SUBJECT: Forwards response to RAI re review of request for amend dtd 970929 for TS related to main steam line isolation signal setpoints.

Subject: Response to Request for Additional Information (RAI)
Rochester Gas & Electric Corporation
R.E. Ginna Nuclear Power Plant
Docket No. 50-244

Reference: Letter from G.S. Vissing, NRC, to R.C. Mecredy, RG&E, Subject: *Request for Additional Information - Review of Request for Amendment Dated September 29, 1997 - Change to the Technical Specification Related to the Main Steam Line Isolation Signal Setpoints (TAC No. M99702)*, dated April 3, 1998.

Response to RAI of April 3, 1998

Figure 1

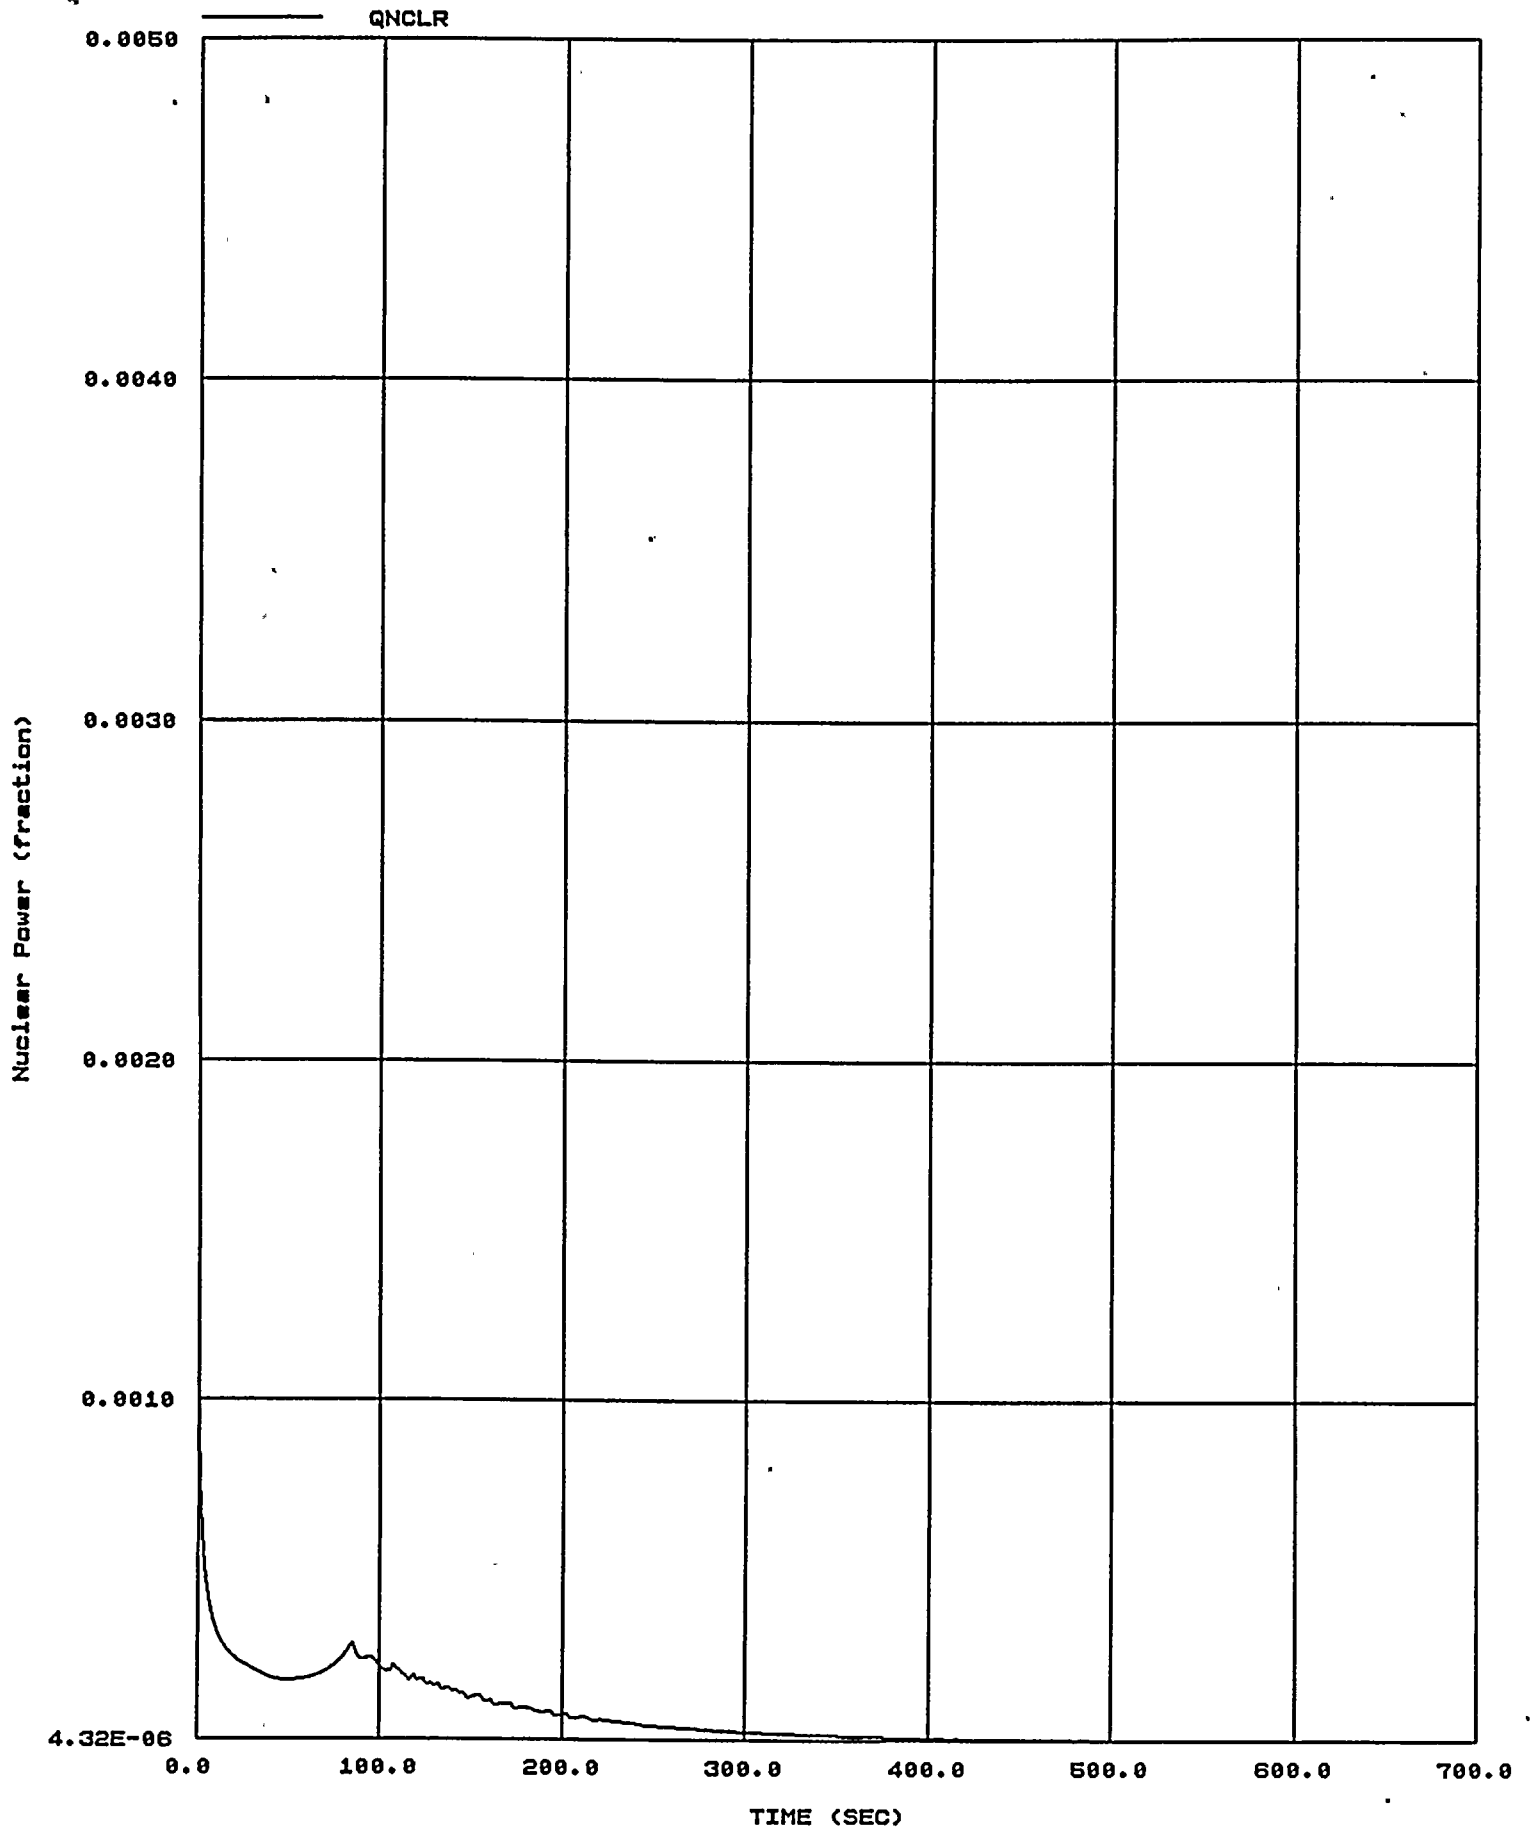
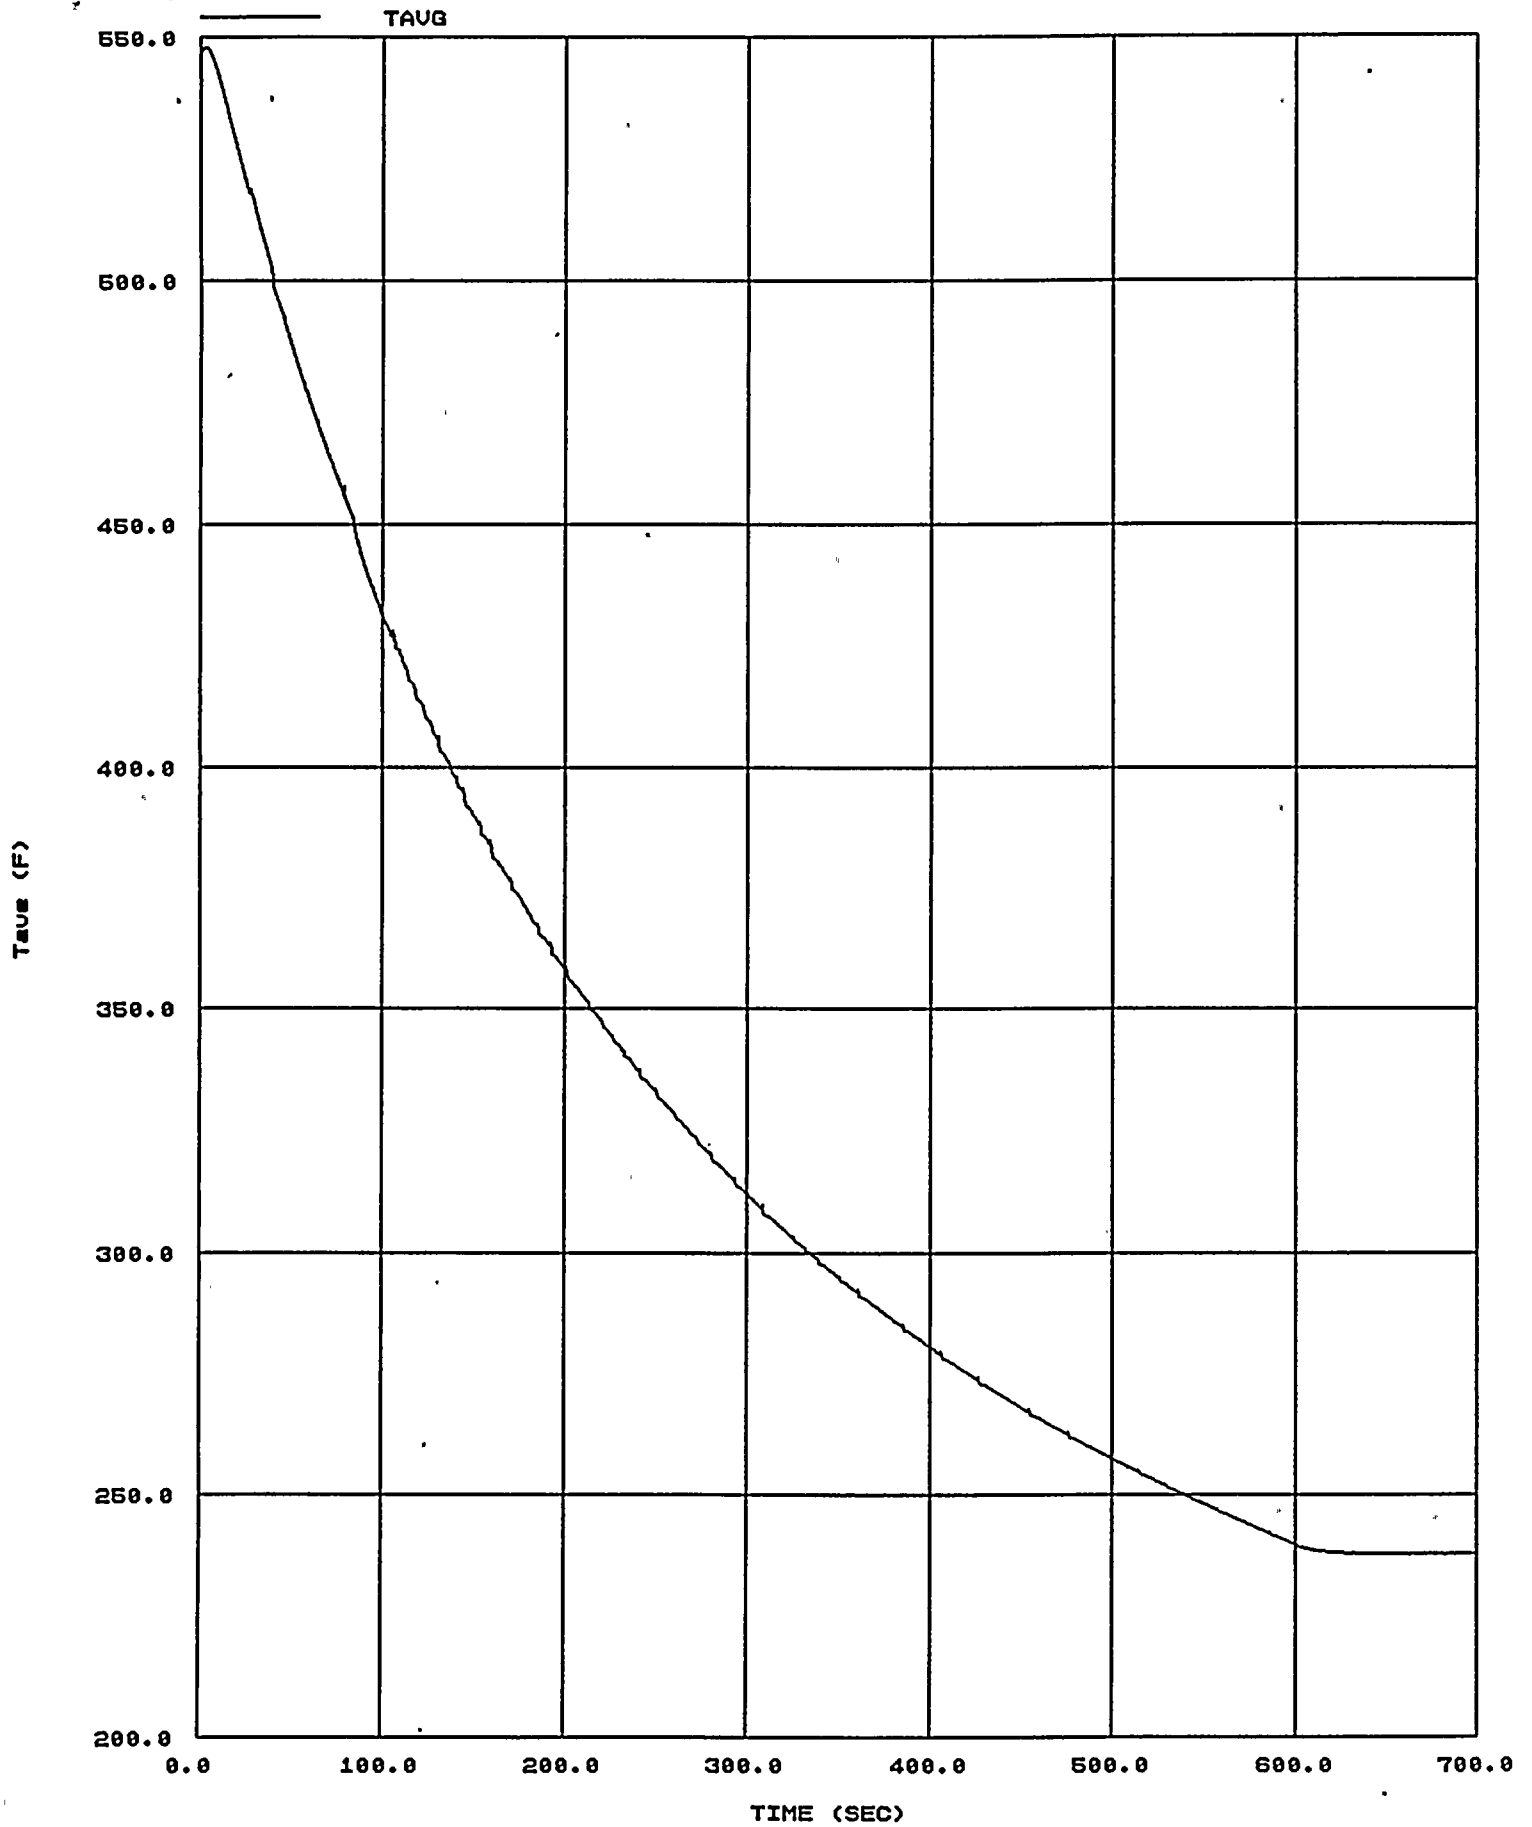
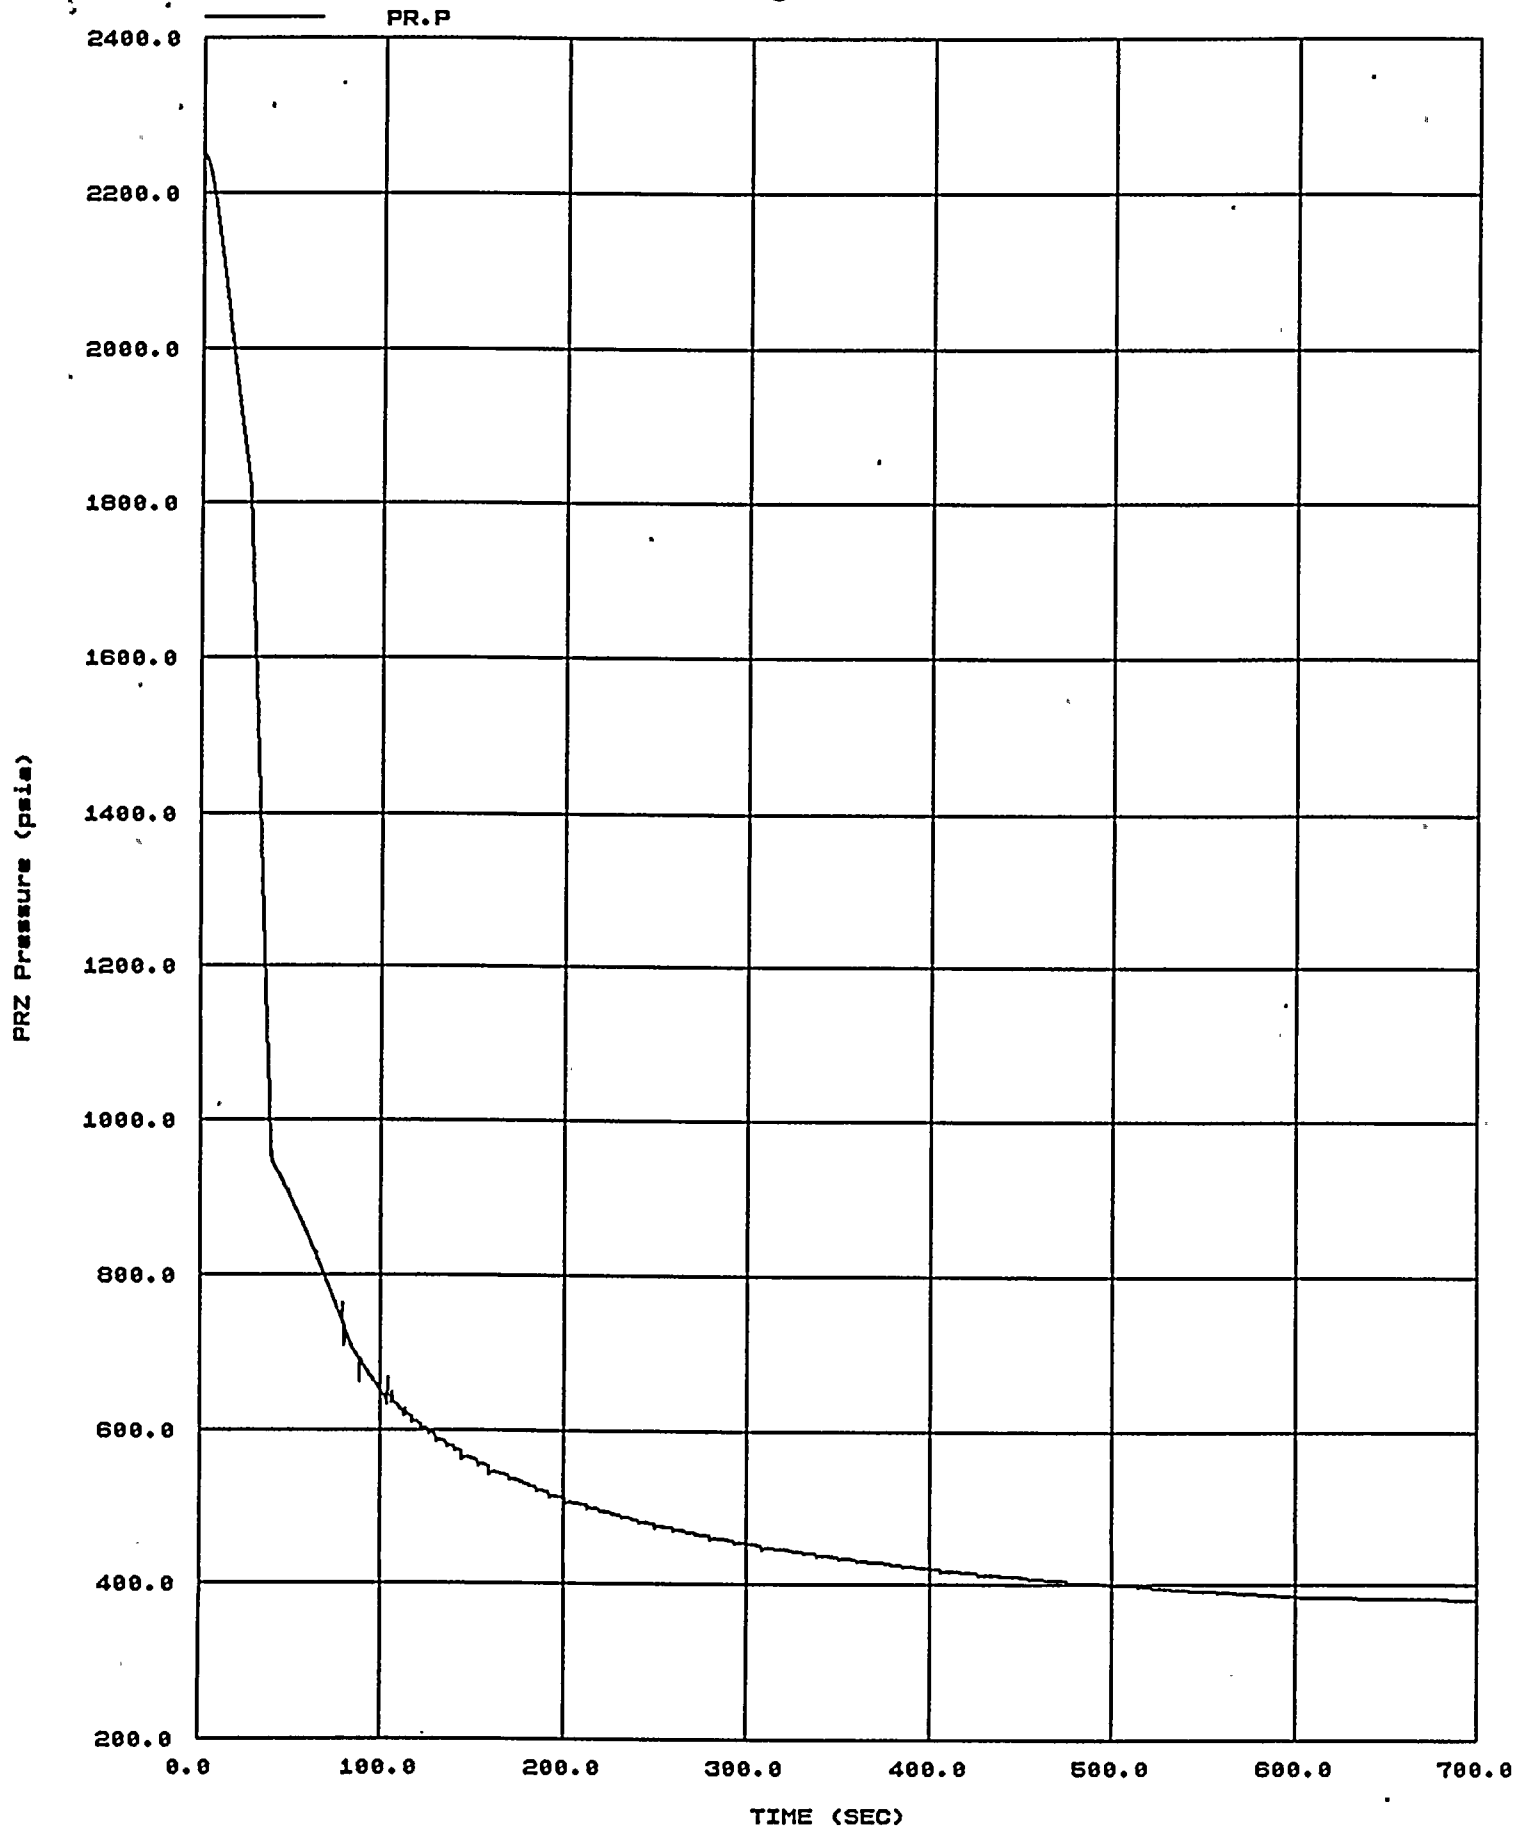
2. *Please provide the results of your reanalysis.*

Attached Figures 1 through 7 represent parameters from Case 5-O. Figures 8 through 14 represent parameters from the 0.66E6 lbm/hr steam line break in one steam generator described in the February 6, 1998 RG&E letter (hereafter referred to as Case SLB). A comparison of the parameters shows:

- a. Resulting nuclear power is less for Case SLB;
- b. Resulting RCS temperature reduction is less for Case SLB;
- c. Resulting pressurizer pressure reduction is less for Case SLB;
- d. Resulting steam generator pressure reduction is less for Case SLB;
- e. Steam generator mass trends illustrate the difference between a feedwater malfunction and a steam break;
- f. Total reactivity insertion is less for Case SLB but occurs over a longer time frame; and
- g. The rate of reactivity insertion is less for Case SLB.

In summary, the parameters indicate that the Case SLB is less severe than Case 5-O and that the limiting criteria with respect to the reactivity insertion rate is less than that for Case 5-O. Therefore, UFSAR Case 5-O remains bounding.
